| Date: 03/2007<br>Bulletin #: 46 004 07 (012) <b>R</b> |                       | Source: SI 09/2007<br>BMW Motorrad USA<br>Service and Technical |                           |         |                     |                |

### **\*\*Recall 07V-151: Replacing Frame Bottom Section\*\***

**Subject:** Replacement of frame bottom section of F650 GS/Dakar models

**Model:** F 650 GS (R13 facelift), F650 GS Dakar (R13 facelift)

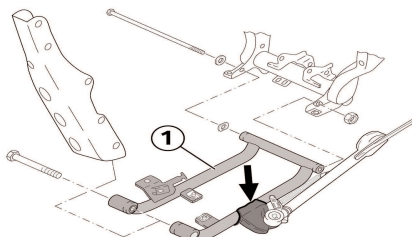
**Details:** On account of a deviation from standard procedure in a welding process, the weld (arrow) between side-stand pivot mount and frame bottom section might not be accurately positioned.  
In order to ensure that the side stand retains its load-bearing capability under all circumstances, frame bottom section (1) of each motorcycle affected will need to be replaced.

The frame bottom section (1) of each of the motorcycles affected has to be replaced.

**Production Solution:** The frame manufacturer has corrected the short-term deviation from standard procedure in the welding process .
